SI B54 01 18
Special Roofs

CONVERTIBLE TOP HEADLINER IS WORN ABOVE REAR WINDOW

F23 (2 Series Convertible)		
----------------------------	--	--

F23 CONVERTIBLE TOP HEADLINER WEAR REPAIR

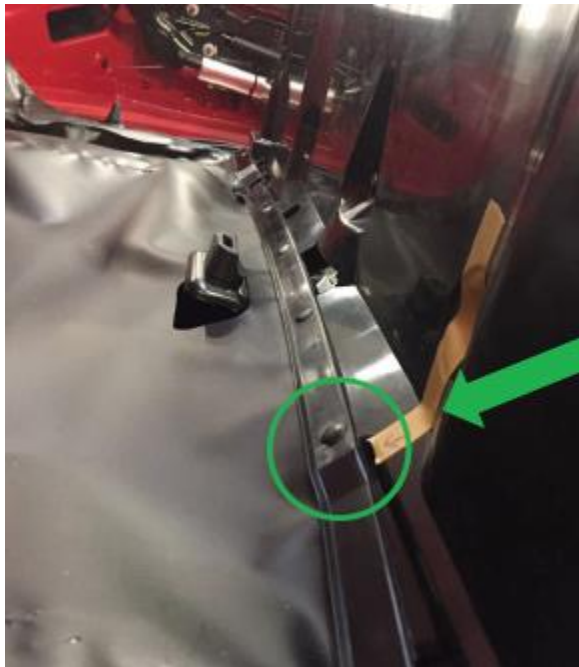
Verify that holes have been worn through the headliner, above the rear window in the area shown to the left.

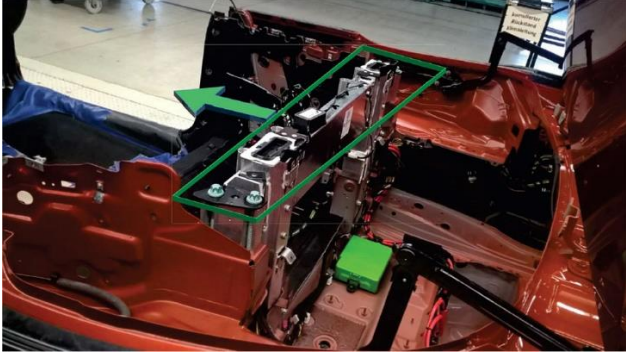
1. Begin by taping 2 sheets of printer paper together length wise to form one long sheet.
2. Starting with the convertible top in the position shown to the left, drape the paper over the back of the rear seat headrest and rollover protection.
